Subject: VIRGIL C. SUMMER NUCLEAR STATION (VCSNS)
DOCKET NO. 50/395
OPERATING LICENSE NO. NPF-12
RESPONSE TO REQUEST FOR ADDITIONAL INFORMATION
LICENSE AMENDMENT REQUEST LAR-02-2767
STEAM GENERATOR INSPECTION FREQUENCY

**South Carolina Electric & Gas Company (SCE&G)
Virgil C. Summer Nuclear Station (VCSNS)
Response to NRC Request for Additional Information (RAI)
Regarding License Amendment Request LAR-02-2767
Steam Generator Inspection Frequency**

Figure TB 1.17

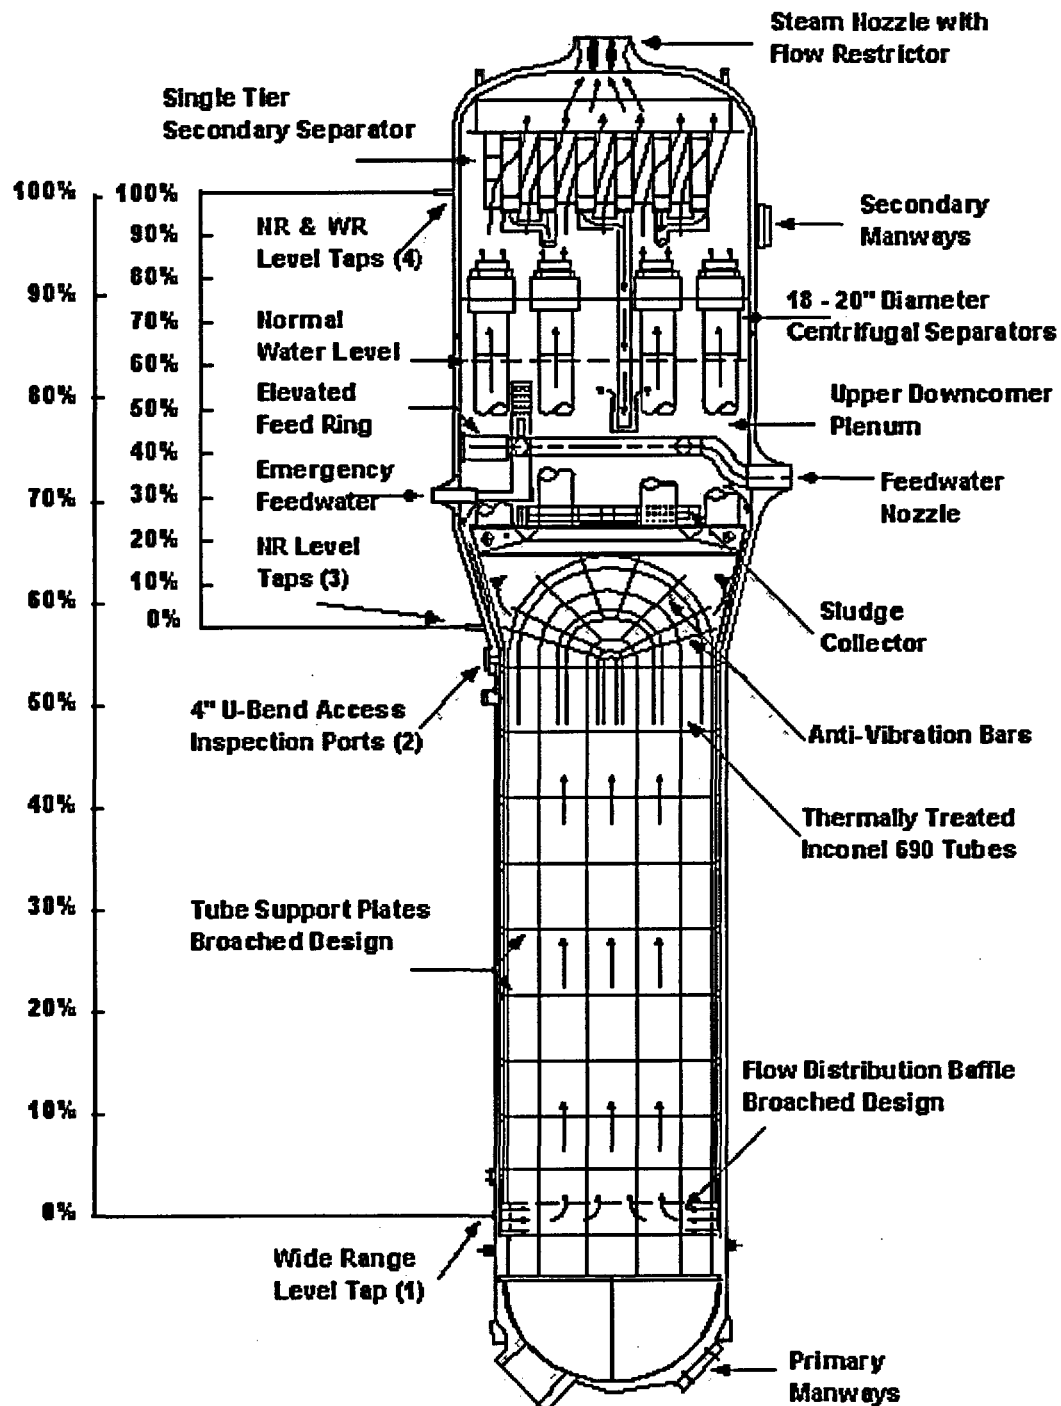
2. In your submittal documenting past inspection results you reference various support structures (e.g. AV7) and various tube locations (e.g. R25C26). In order to ascertain the locations of these indications, please provide a schematic of the Model Delta 75 steam generator identifying the nomenclature of the tube supports. In addition, provide a tubesheet map identifying the rows and columns of the tubes.

A schematic of the Steam Generator (SG) structure and a tube sheet map showing row and column designations is attached.
